FORD 4R100 "UPDATE HANDBOOK"

FORD 4R100 "UPDATE HANDBOOK"

Since the introduction of the 4R100 transmission in model year 1998, there have been many engineering changes to improve Pleaseability, Reliability and Durability concerns. These changes have affected most every part used in this transmission. This "Update Handbook" will explain each change, the reason for the change, and any parts interchangeability concerns created by the change, along with any part numbers needed to update your transmission.

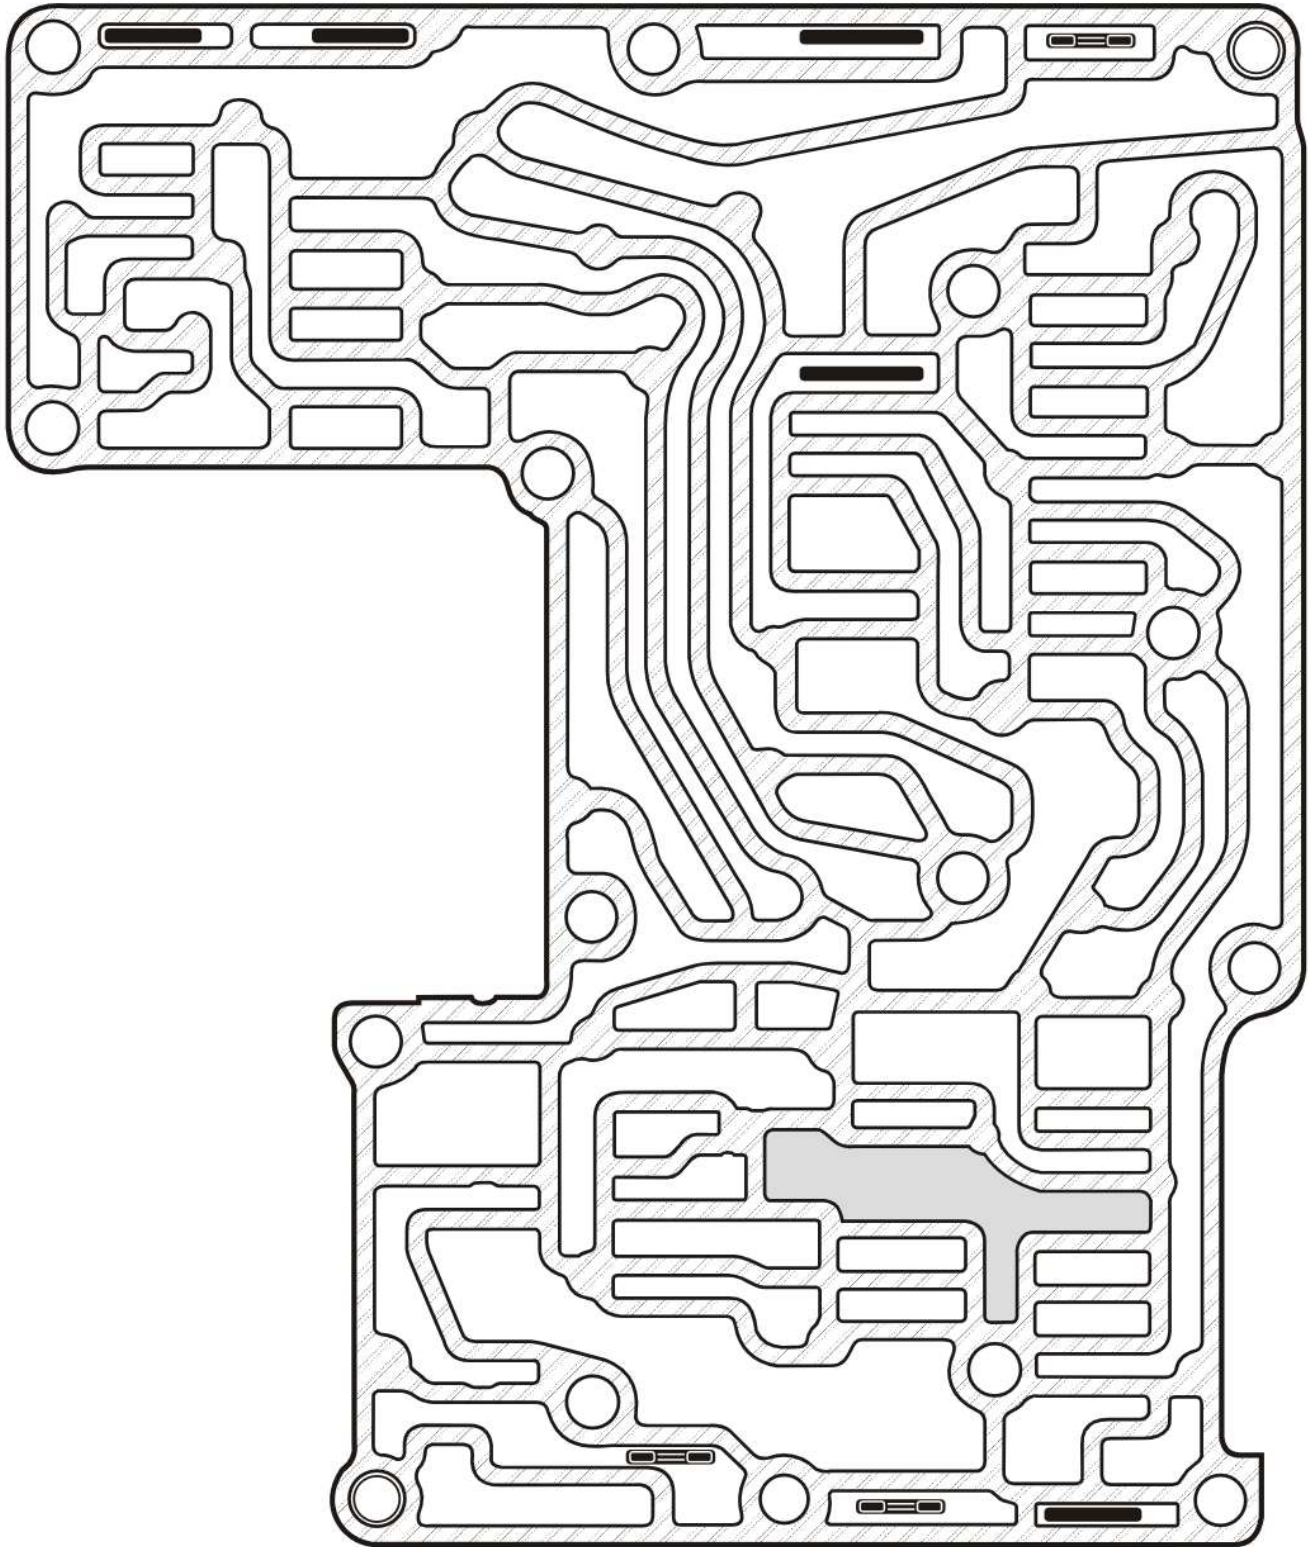
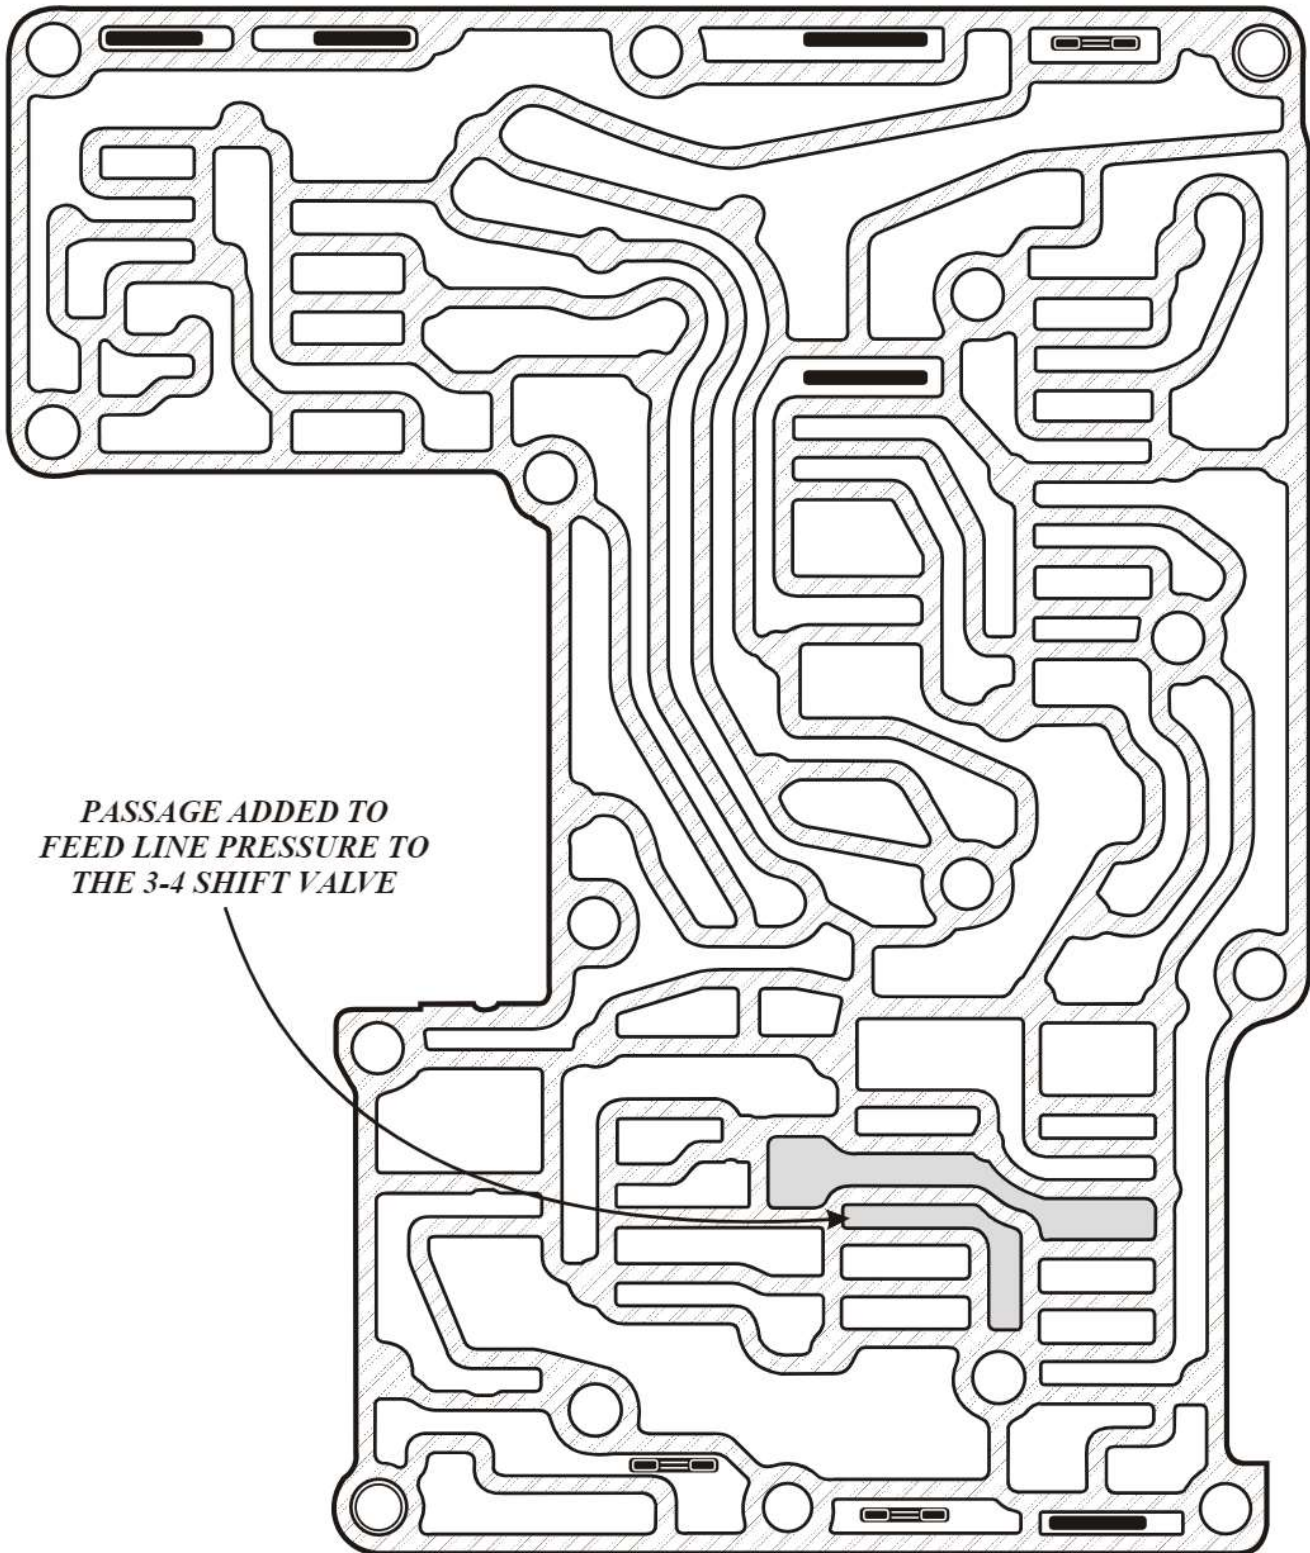
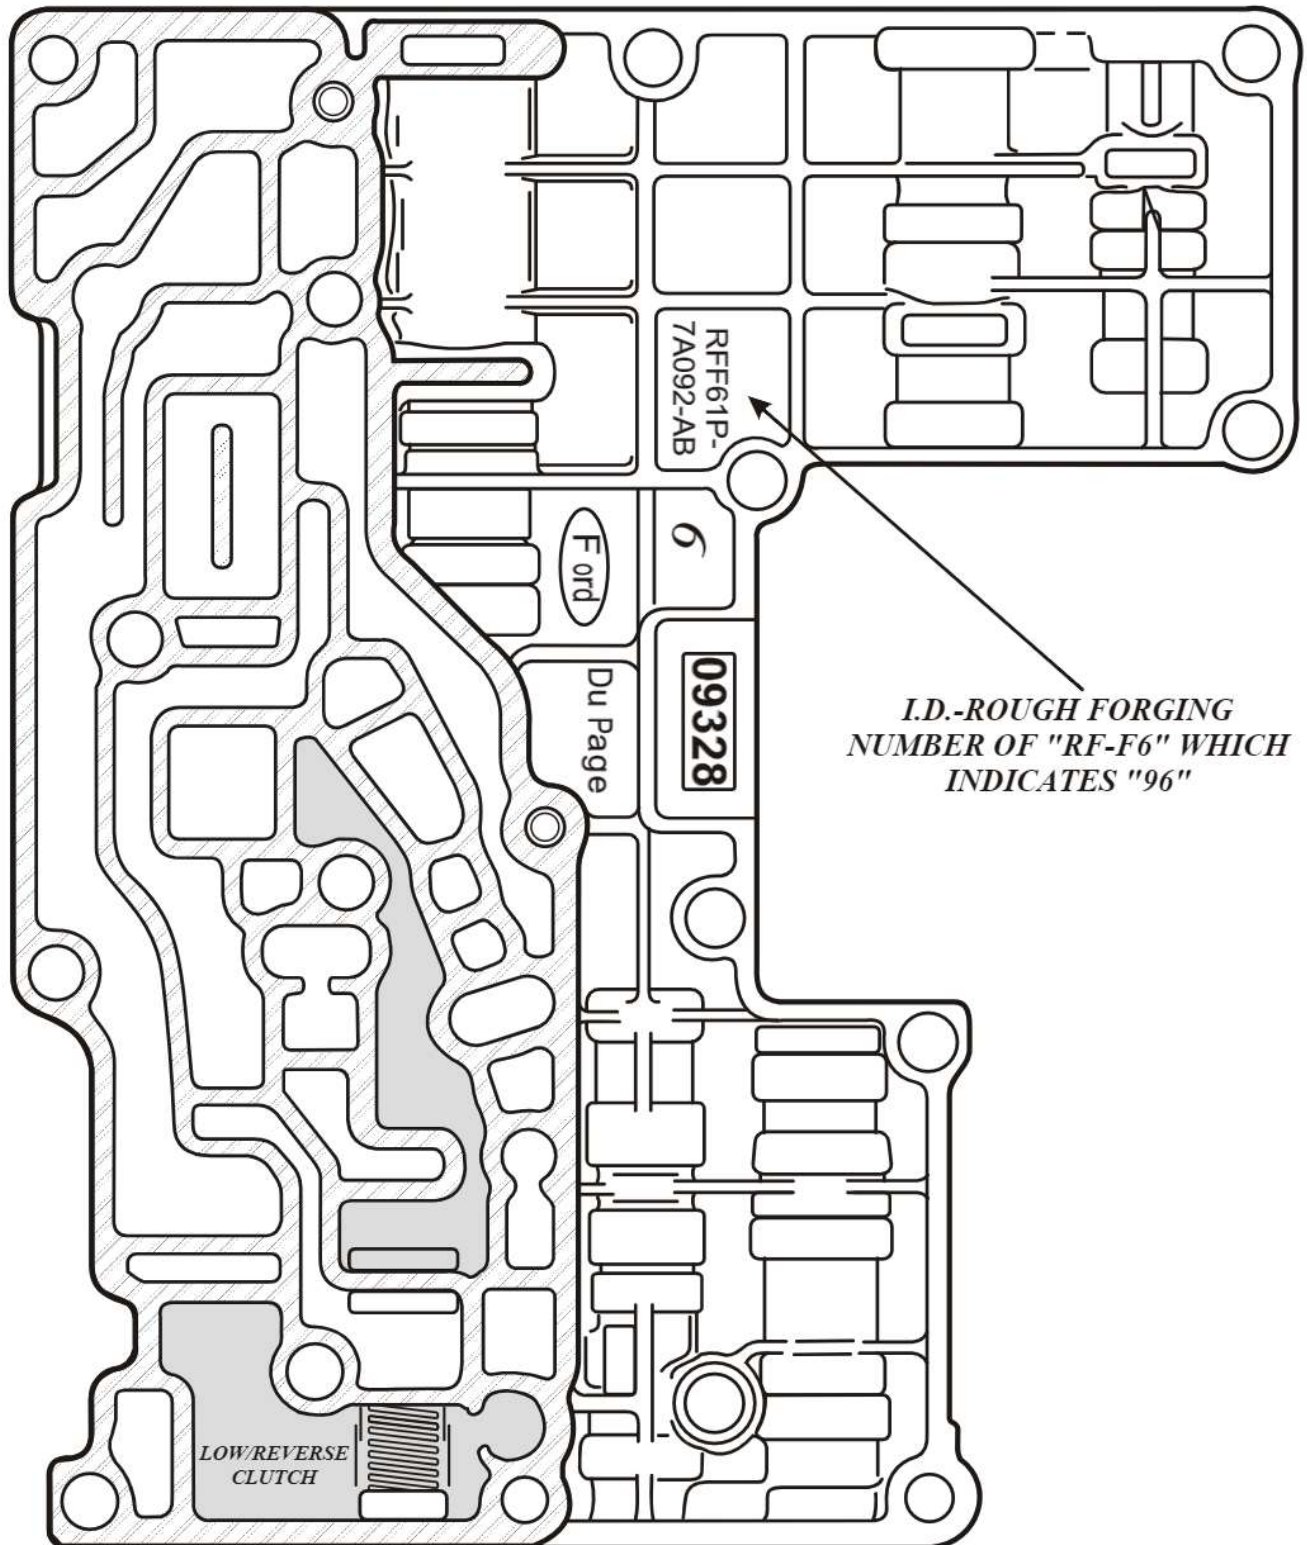
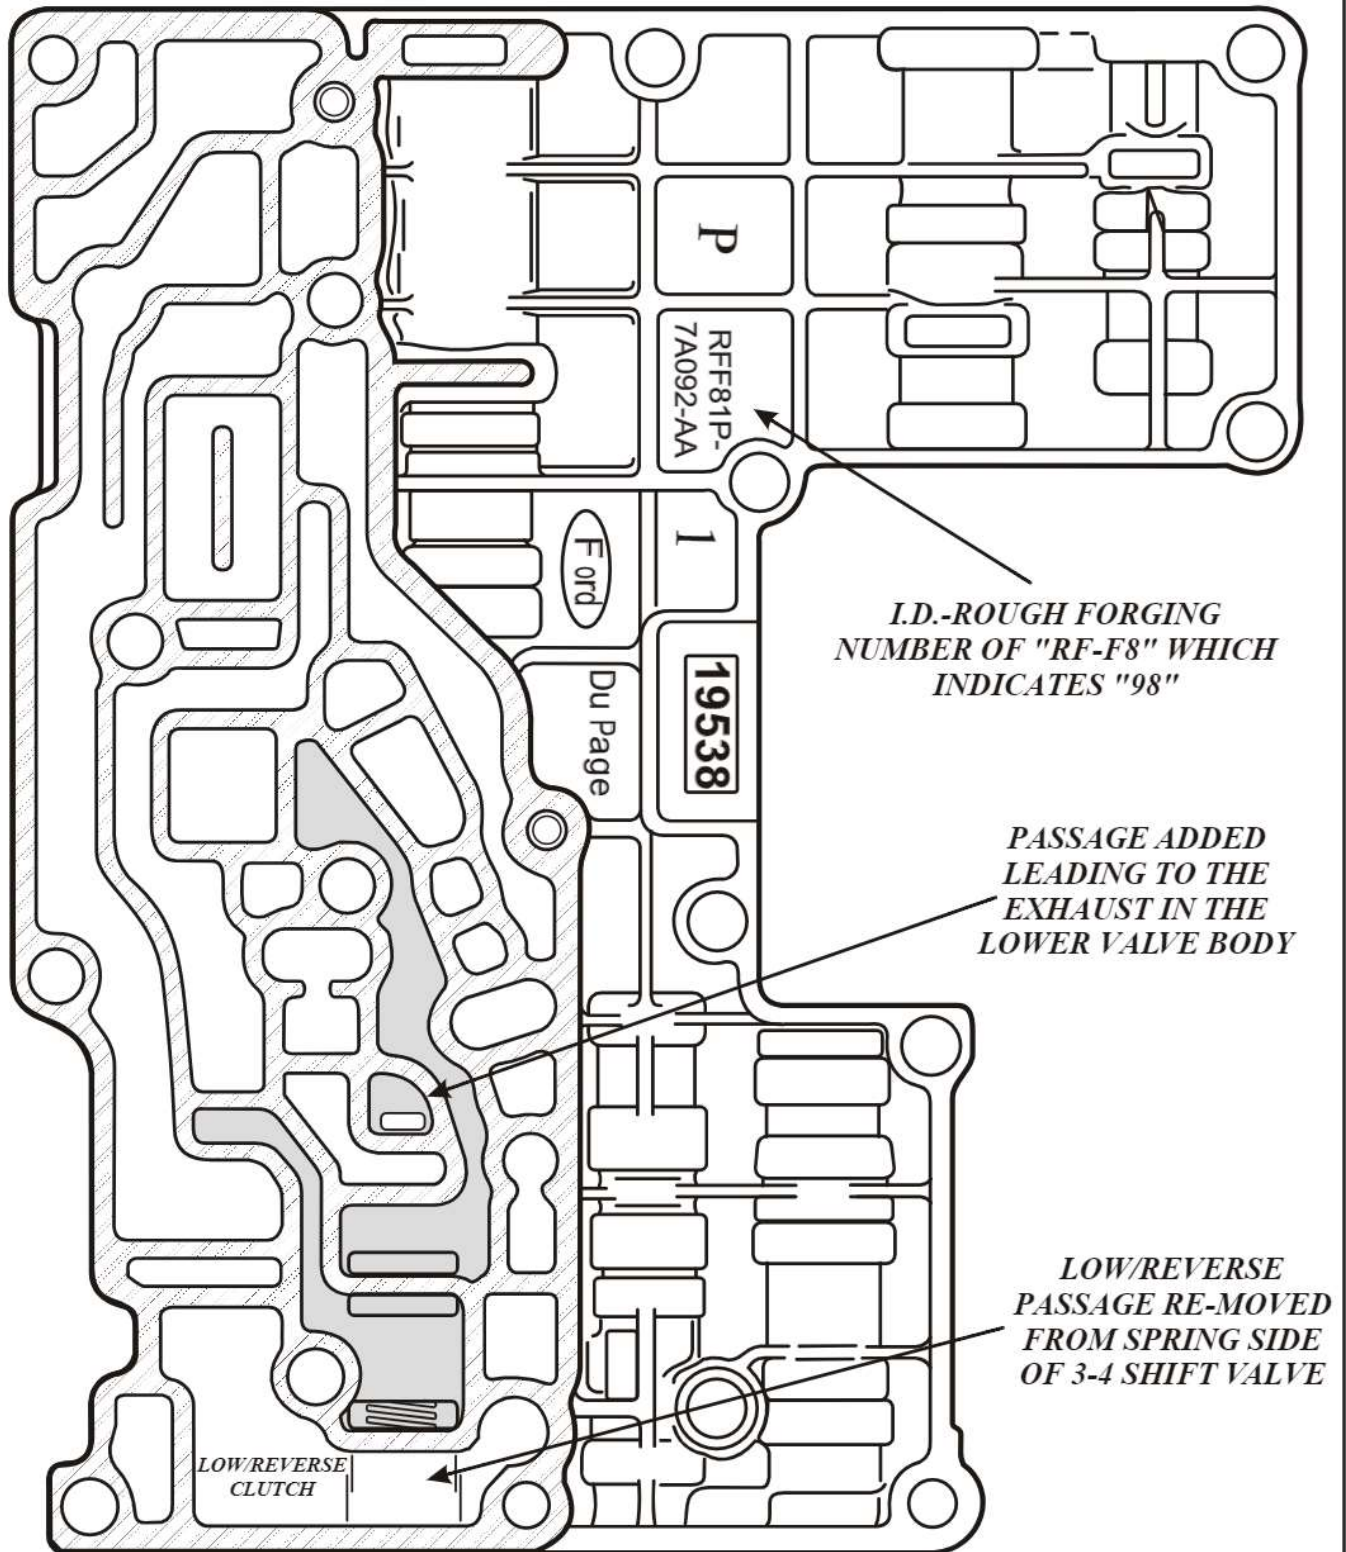
- (3) **MAIN VALVE BODY:** A passage was added on the "Upper Side" of the Main Valve Body on "PTO" versions, as shown in Figure 34, to supply Line Pressure to the 3-4 Shift Valve. A passage was also added, on the "Lower Side" of the Main Valve Body, to connect the 3-4 Shift Valve (Coast Clutch Circuit) to an exhaust as shown in Figure 36. The spring side of the 3-4 Shift Valve was also separated from the Low/Reverse circuit as shown in Figure 36. Refer to Figures 33 thru 36 for identification of "NON-PTO" and "PTO" Main Valvebody's.
